UNITED STATES
NUCLEAR REGULATORY COMMISSION
REGION III
799 ROOSEVELT ROAD
GLEN ELLYN, ILLINOIS 60137

IE Bulletin No. 80-20

FAILURES OF WESTINGHOUSE TYPE W-2 SPRING RETURN TO NEUTRAL CONTROL SWITCHES

FIGURE 1:

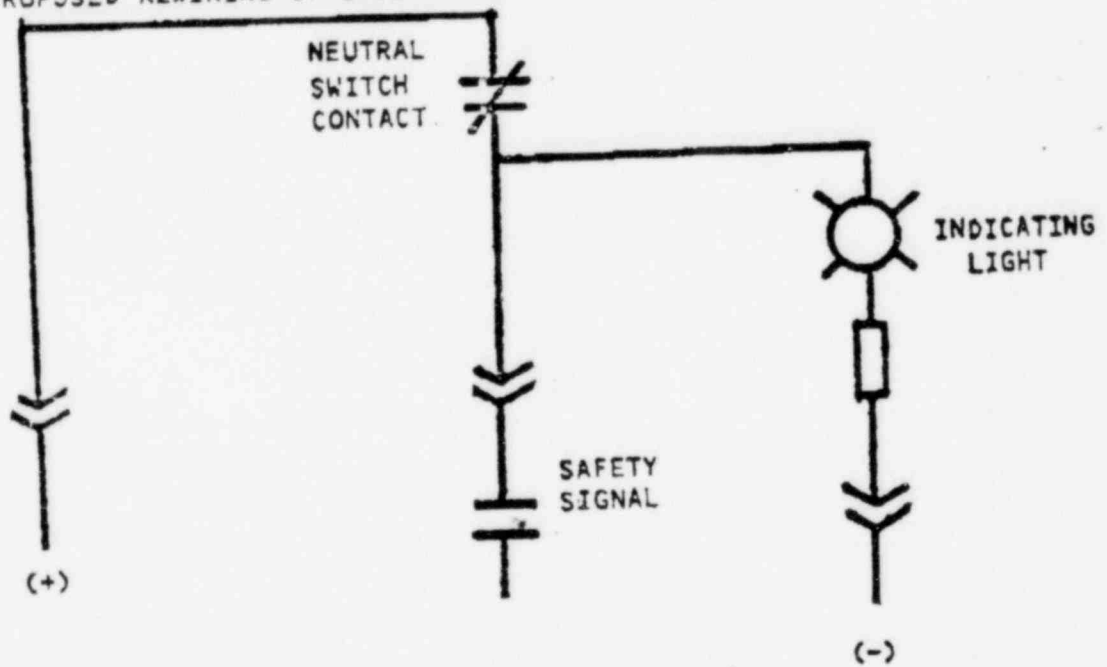
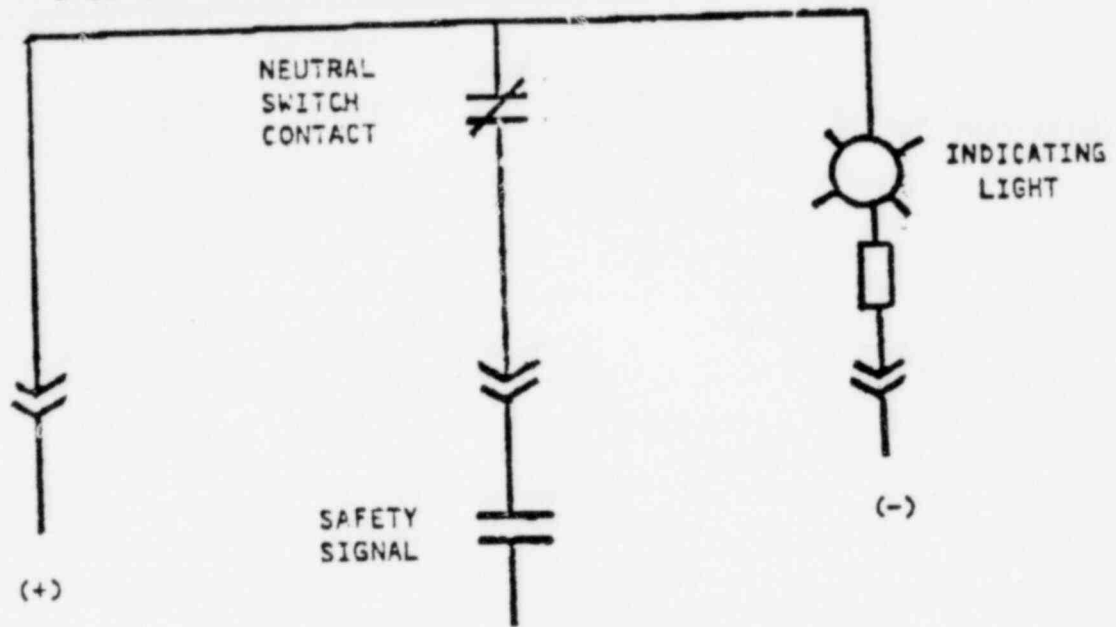
A review of this matter by Westinghouse led to the issuance of NSD Technical Bulletin No. NSD-TB-80-9 to the utility owners of all Westinghouse operating plants. The recommendations contained in the Westinghouse technical bulletin include: (i) testing the neutral position contacts of the subject W-2 switches for continuity, and (ii) rewiring of the indicating light circuit to permit the early detection of a neutral contact failure as shown in Figure 1.

Depending on how the indicating light circuit is wired, loss of continuity thru the neutral position contact of a W-2 switch could remain undetected until the equipment associated with the switch were called upon to operate. Since such a failure would be equivalent to by-passing the system associated with the switch, consideration should be given to rewiring the switches used in safety-related applications as shown in Figure 1. Such rewiring would provide an acceptable means for detecting contact failure, provided the indicating light is in the control room and readily visible by the operator. If the indicating light is not so located, consideration should be given to annunciating the neutral position contact failures at the control room to alert the operator of the inoperable status of a safety-related system. In addition, consideration should be given to adding redundant contacts to the W-2 switches or to replacing the W-2 switches with others having a more positive contact wiping action.

3. Licensees of operating plants and holders of construction permits shall describe the longer term corrective measures planned and the date by which such measures will be implemented by actual installation or by design change, as appropriate. As a minimum, the longer term corrective measures should include rewiring the indicating light as shown in Figure 1 provided the light is readily visible to the control room operator. If not, failures of the neutral position contacts should be annunciated in the control room.

REWIRING OF INDICATING LIGHT CIRCUIT OF W-2 SWITCHES
AS RECOMMENDED BY WESTINGHOUSE TECHNICAL BULLETIN NSD-TB-80-9
